OFFICIAL NOTICE OF DECISION

CITY OF ALBUQUERQUE
PLANNING DEPARTMENT
DEVELOPMENT REVIEW BOARD

Project# 1005357

Project Name: UNIVERSITY OF ALBUQUERQUE URBAN CENTER

PROJECT TITLE	OXBOW COORS AND ST. JOSEPH'S ALBUQUERQUE, NM		
PROJECT MANAGER	JOB NO.	DRAWN BY:	
SHEET TITLE	ALLUSTRATIVE LANDSCAPE SOUTH		
DATE	12/28/07	SCALE	AS NOTED
SHEET NO.	L2A

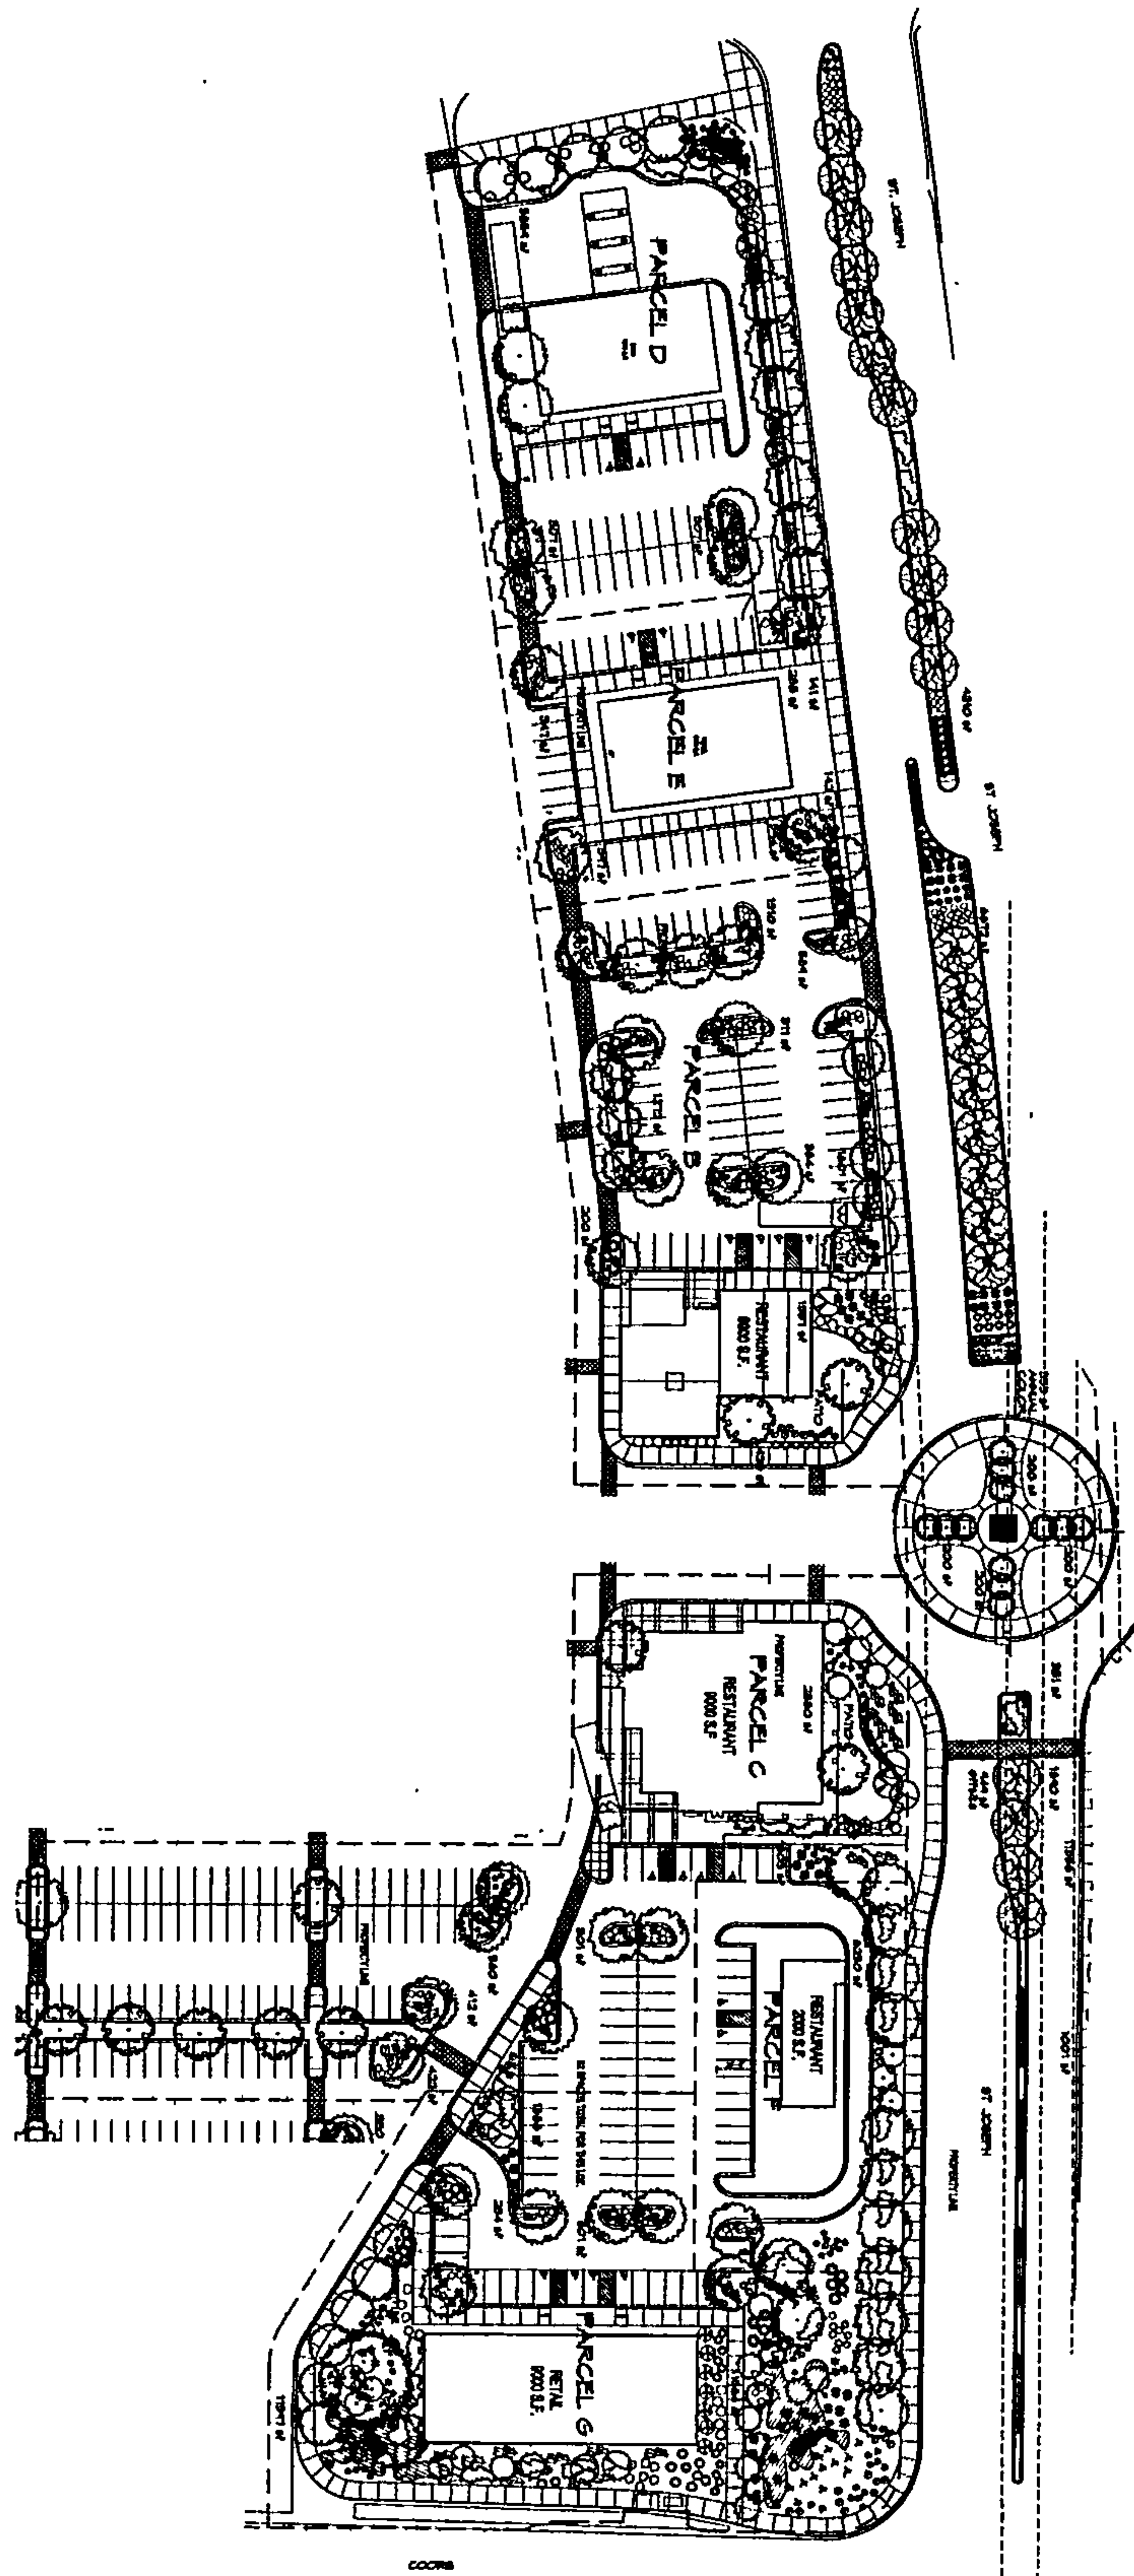
- b. The first sheet labeled AS7 shall be labeled AS6.
 - c. Illustrative is spelled incorrectly on Sheet L2A.
 - d. On Sheet 15 of 15 retaining is spelled incorrectly.
